**DATE:** 12.14.2018  
**TO:** ProTrak  
**FROM:** Mitesh Baxi  
Traffic Engineering

■ **COURTYARD AT MIDTOWN VILLAGE [TRC Plan Review #3]**

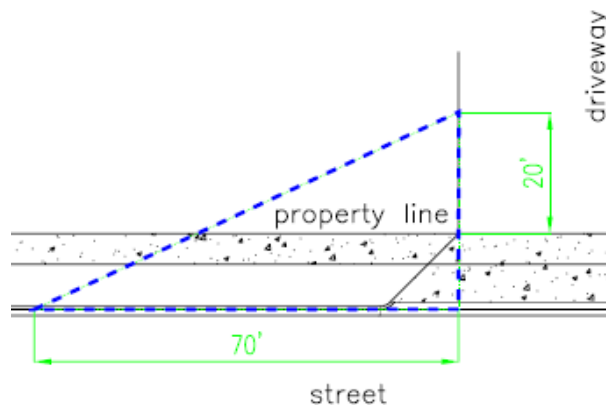
1. The sight distance triangles for the driveways are not implemented as per City standards. The City's 20'x70' sight distance triangle shall be measured as per the image below. [Sec.18-529(c) (3) CofW LDC]. 20' for the site distance triangle must be measured from the property line (not the curb line) towards the property.
